PERMANENTE CREEK LONG-TERM RESTORATION PLAN

**Re: Response to Board Comments Letter (dated 11/12/09) [CIWQ Place ID:
234559 (bkw)]
CAO No. 99-018 – Permanente Creek Long-Term Restoration Plan
Lehigh Southwest Cement Company, Cupertino, California**

Response to Board Comments of November 12, 2009
 Permanente Creek Long-Term Restoration Plan
 Lehigh Southwest Cement Company, Cupertino, California

Comments on Permanente Creek Long-Term Restoration Plan (Nov. 12, 2009, CAO 99-018)

Figure 1-3.4

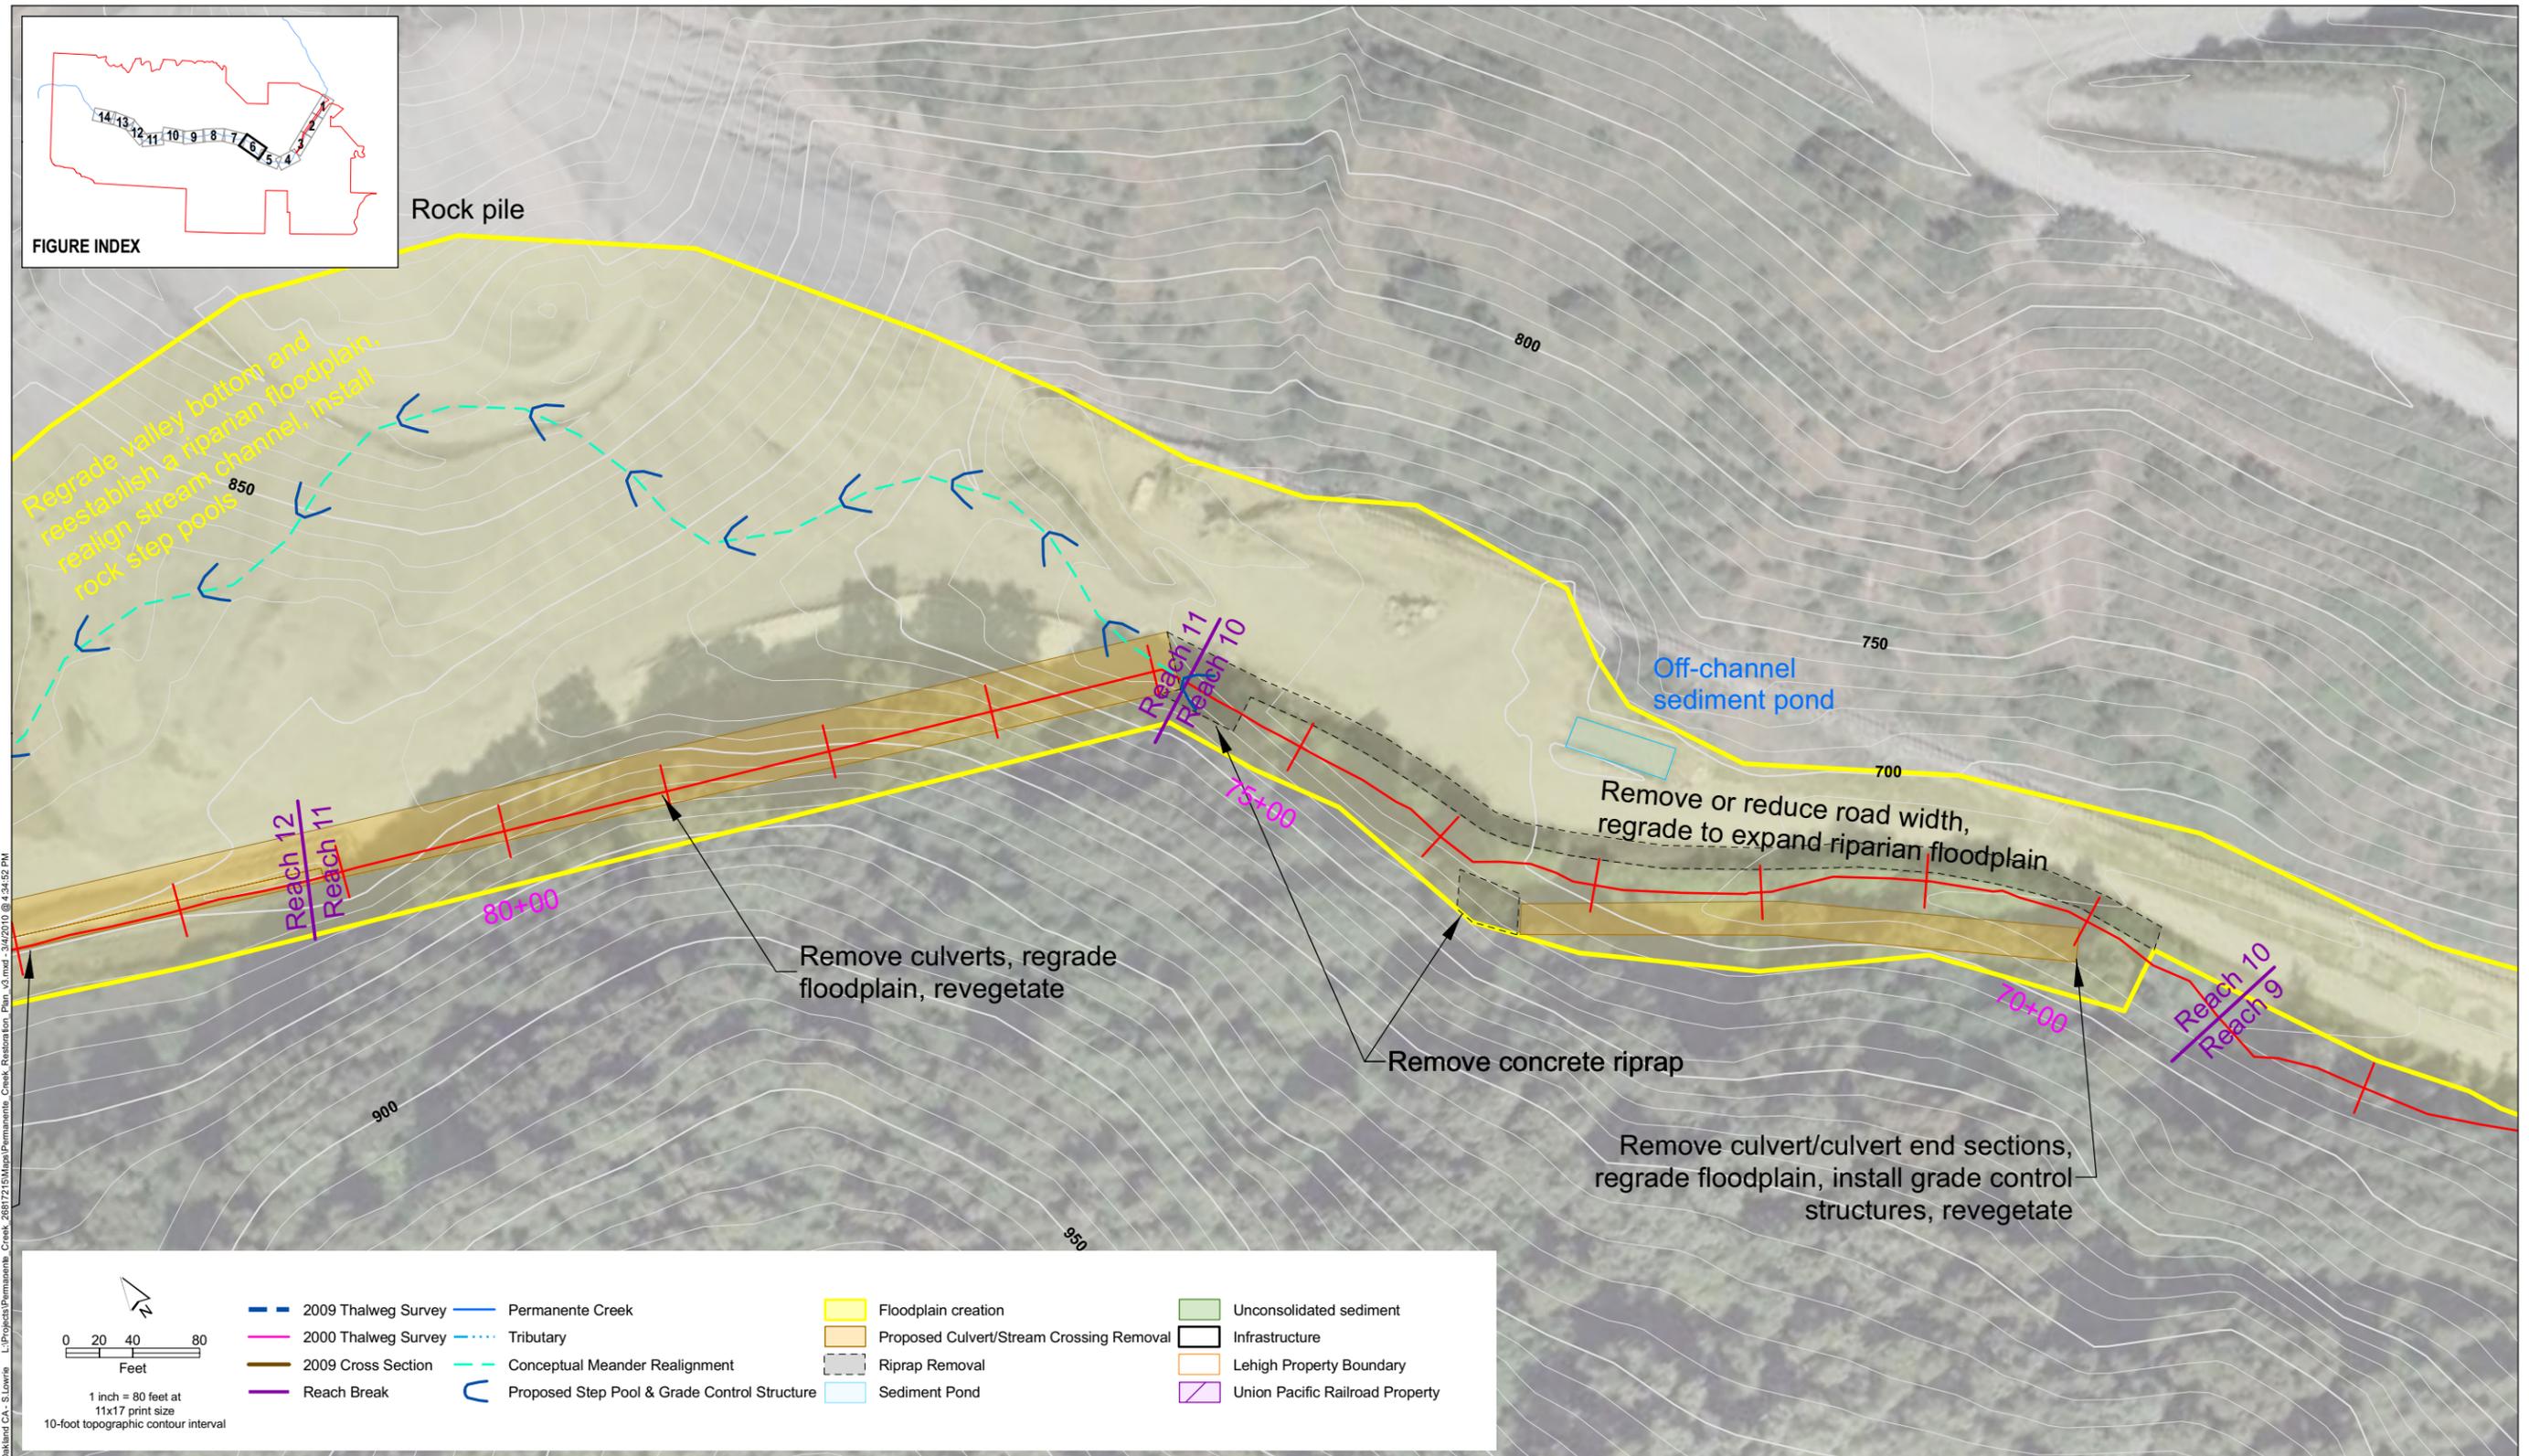
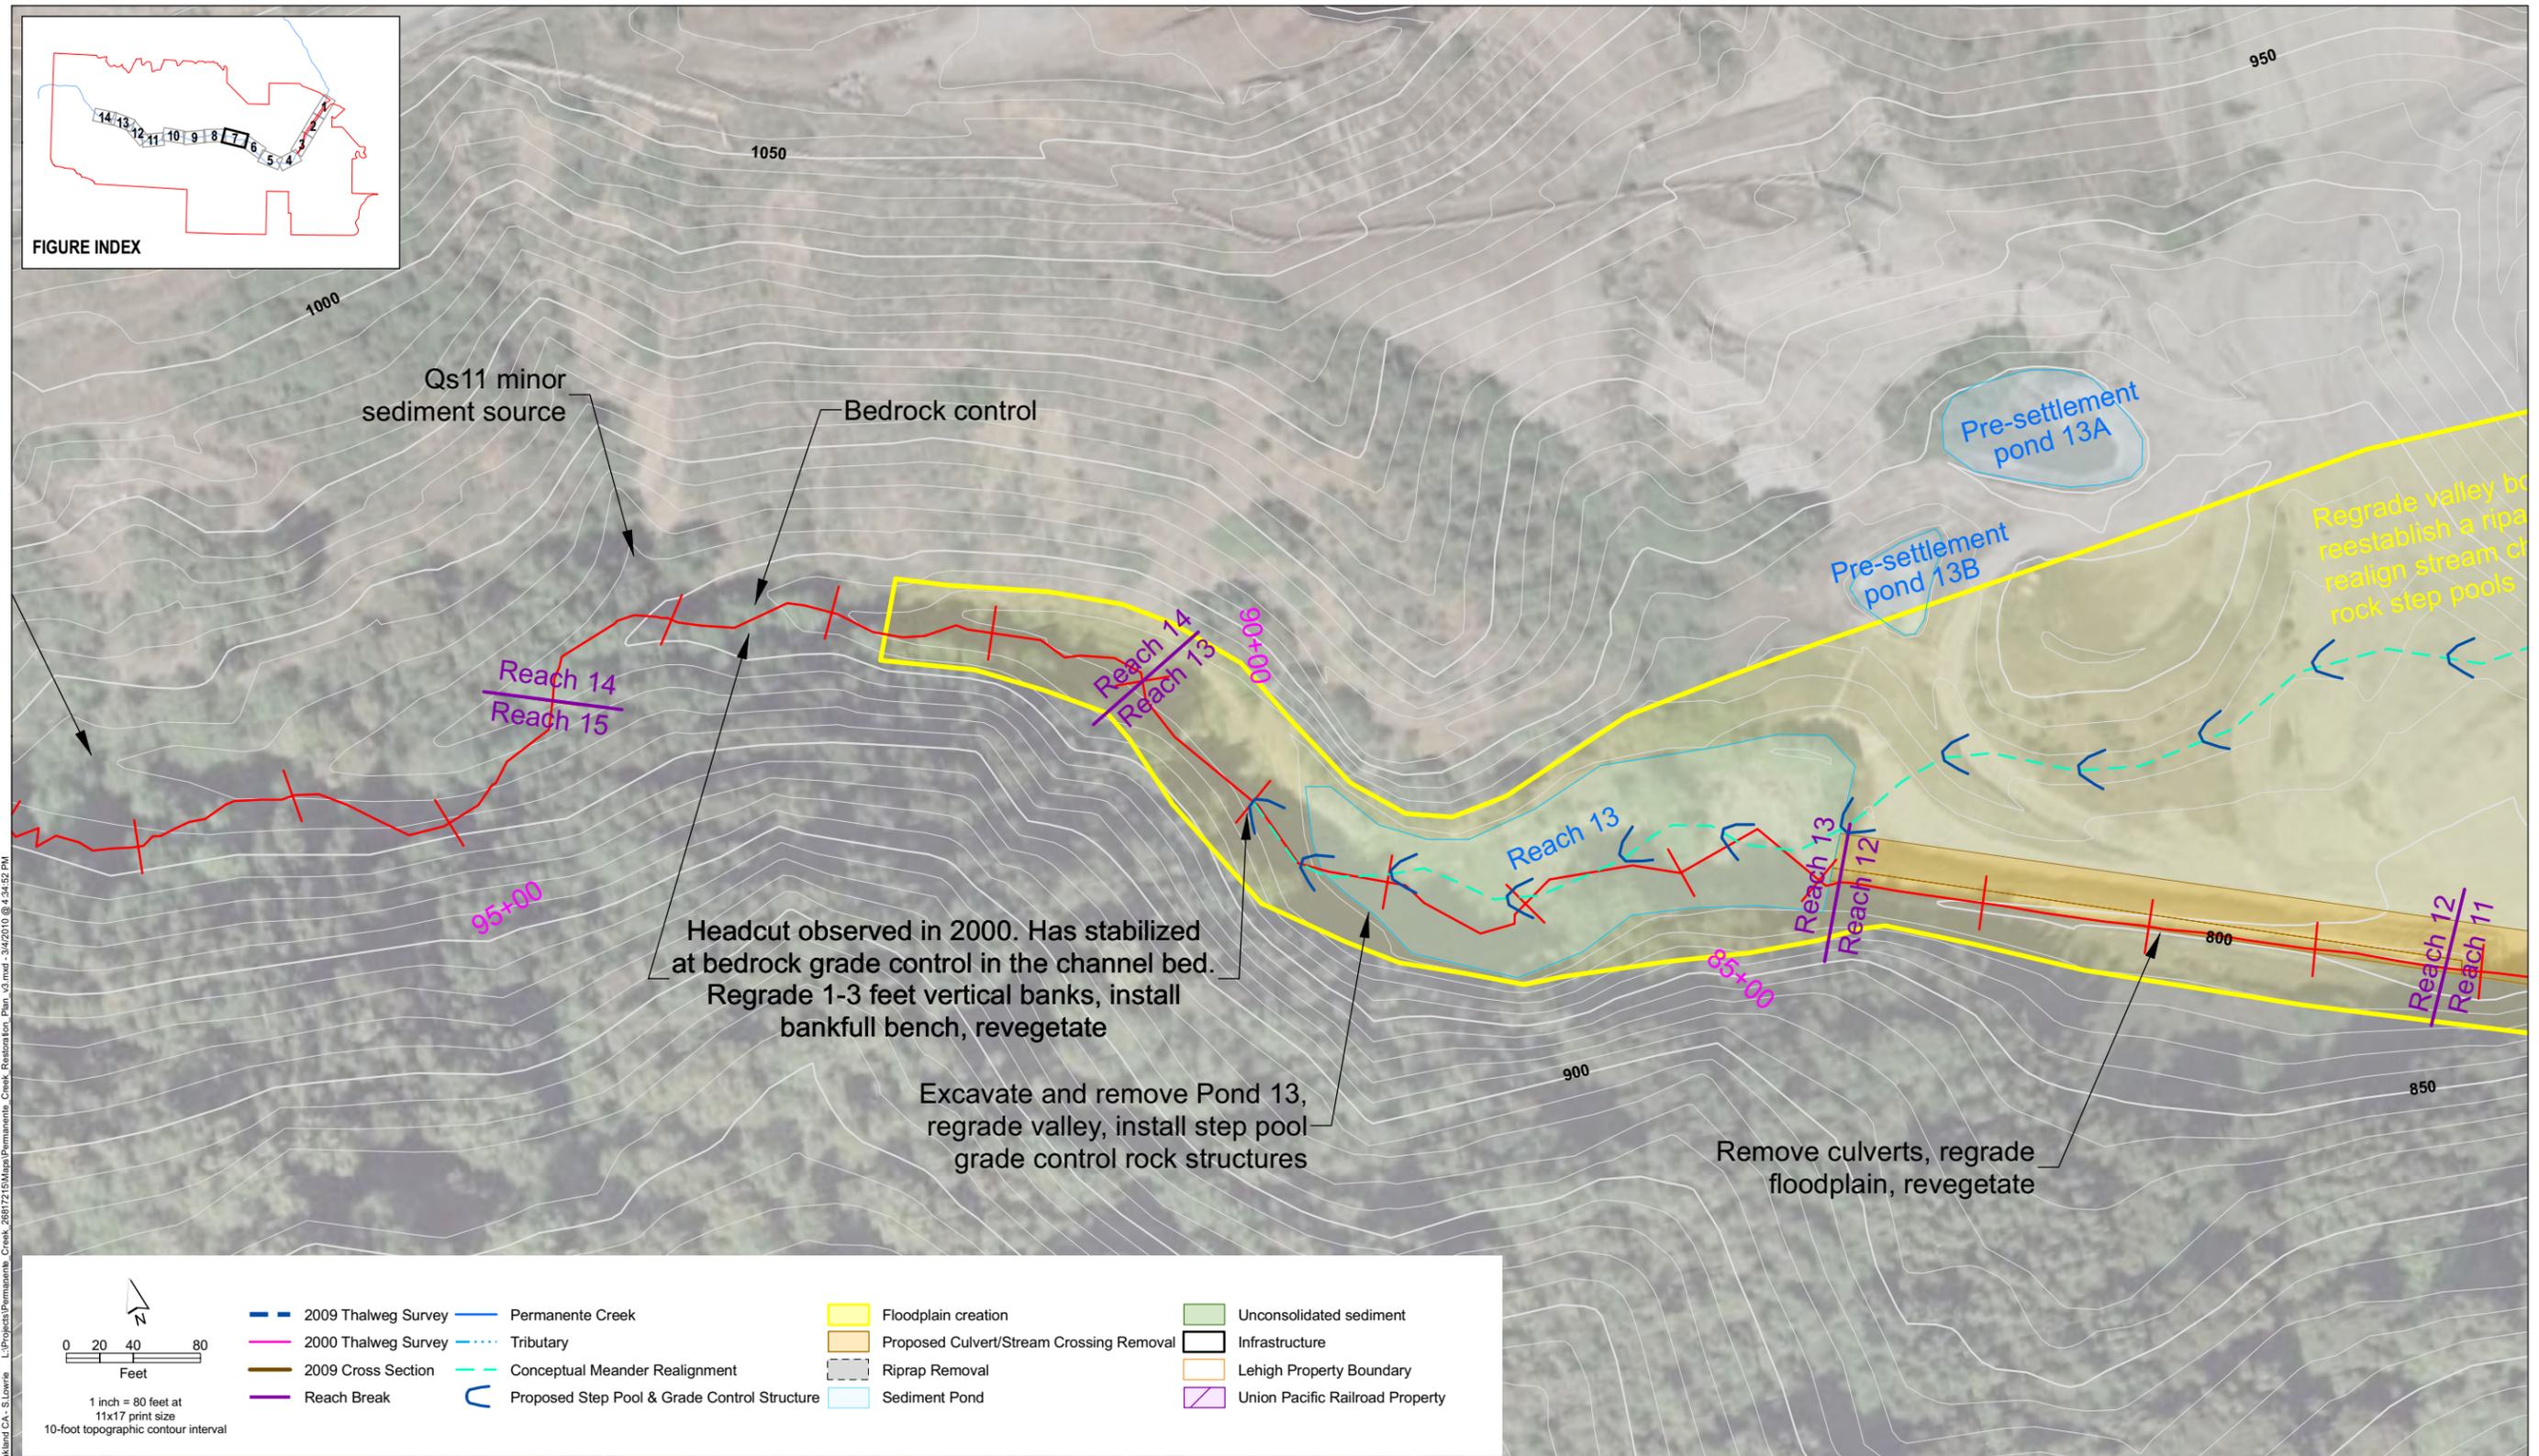
Specific Comment	Document Page	Section	Topic
27	NA	Appendix A	(Figure 1-3)
Comment Text			
The 14 annotated aerial photographs in Figures 1-3.1 through 1-3.14 indicate several significant features (e.g., culverts, ponds). It is not clear if these figures include all in-channel features, or just the in-channel features proposed for removal or modification in the Restoration Plan. Please make sure that all in-channel features are included so that it is easier for Water Board staff to determine if further restoration activities should be assessed for inclusion in the Restoration Plan.			
Comment Response			
The features depicted in Figure 1-3 include all in-channel infrastructure, not just that proposed for removal.

Comment Response			
<p>A new reference system has been simplified. The revised Long-Term Restoration Plan includes cross referencing of the 14 aerial photographs in Appendix A with a new reach designation system. The location nomenclature formerly used in the previous draft, [A] through [R], is no longer used. Please see Table 4-2 and Figure 1-3, where these changes have been implemented. In addition, a new appendix (Appendix B) has been added that correlates the reach nomenclature from the Phase I Report with that of the revised Plan.</p>
